# UNITED STATES PATENT AND TRADEMARK OFFICE

APPLICATION NO.	FILING DATE	FIRST NAMED INVENTOR	ATTORNEY DOCKET NO.	CONFIRMATION NO.
10/797,003	03/11/2004	Akiji Shibata	503.43552X00	3868
20457	7590	08/07/2006	EXAMINER	
ANTONELLI, TERRY, STOUT & KRAUS, LLP 1300 NORTH SEVENTEENTH STREET SUITE 1800 ARLINGTON, VA 22209-3873			CHAMBLISS, ALONZO	
			ART UNIT	PAPER NUMBER
			2814

### **DETAILED ACTION**

**FIG. 9**

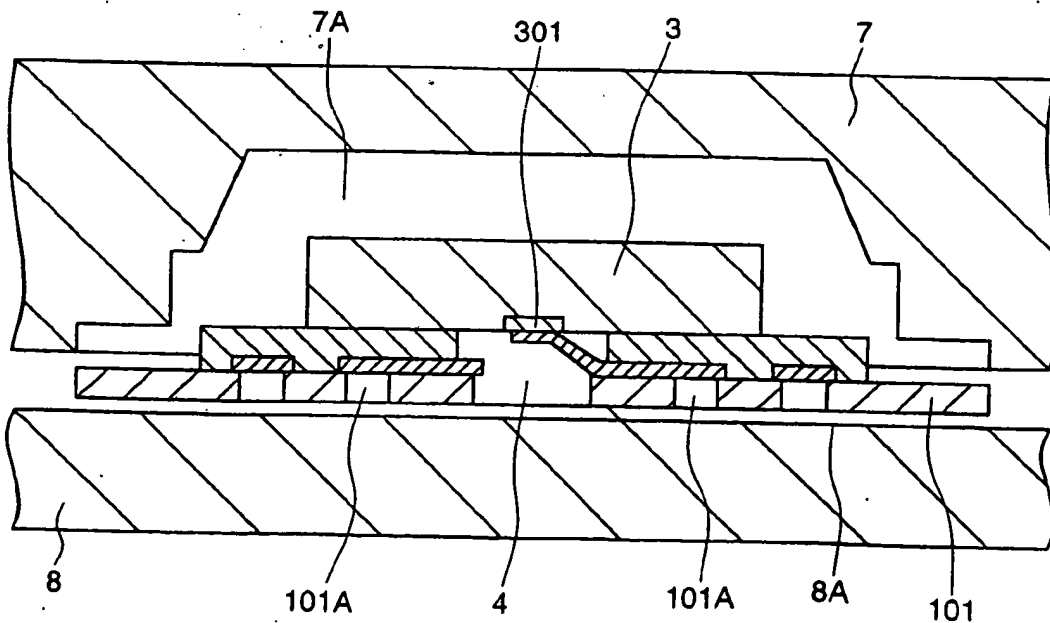
2. The drawings were received on 2/13/06. These drawings are partially approved. The replacement sheet for Figs. 9 and 10 are approved but the replacement sheet for Figs. 11 and 12 are not approved since the "Prior Art" label is still missing above the figures.

*Approved*  
*AC*  
*7/25/06*

FIG. 11

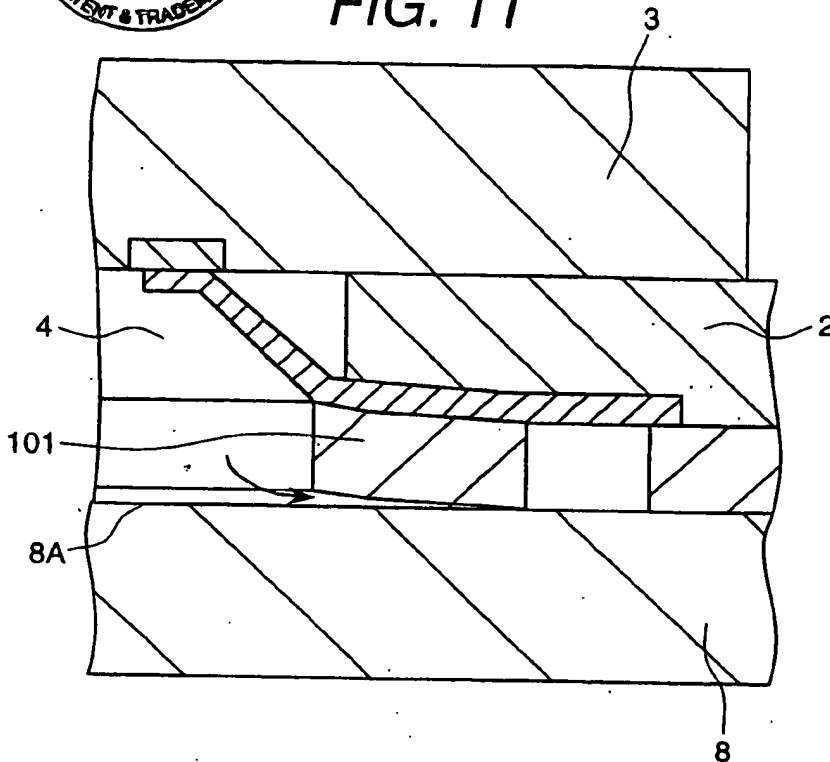
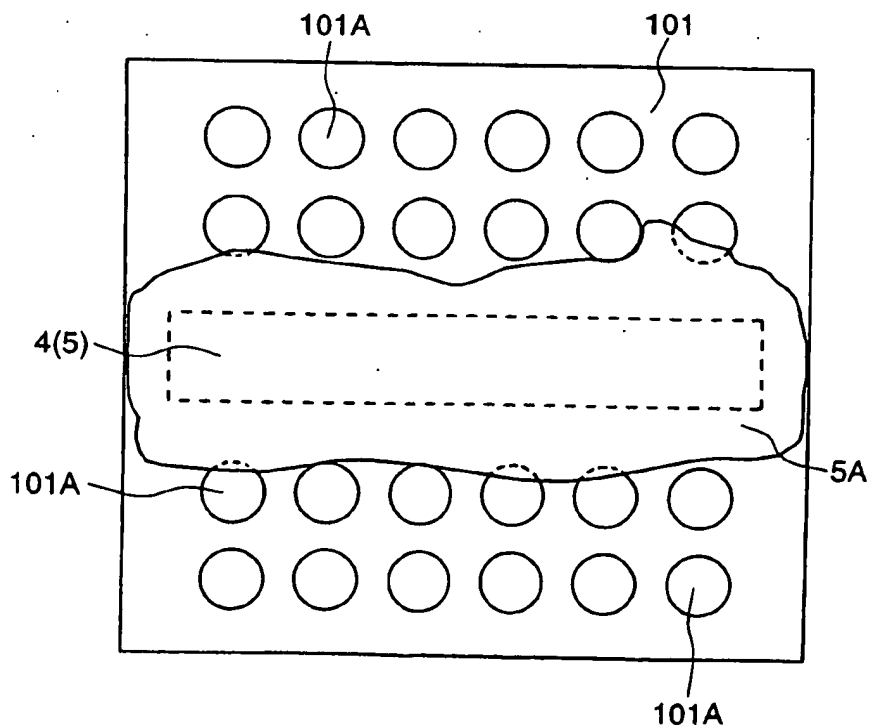
3. Figures 11 and 12 should be designated by a legend such as --Prior Art-- because only that which is old is illustrated. See MPEP § 608.02(g). Corrected drawings in compliance with 37 CFR 1.121(d) are required in reply to the Office action to avoid abandonment of the application. The replacement sheet(s) should be labeled "Replacement Sheet" in the page header (as per 37 CFR 1.84(c)) so as not to obstruct any portion of the drawing figures. If the changes are not accepted by the examiner, the applicant will be notified and informed of any required corrective action in the next Office action. The objection to the drawings will not be held in abeyance.

Not approved  
 JC  
 7/25/06
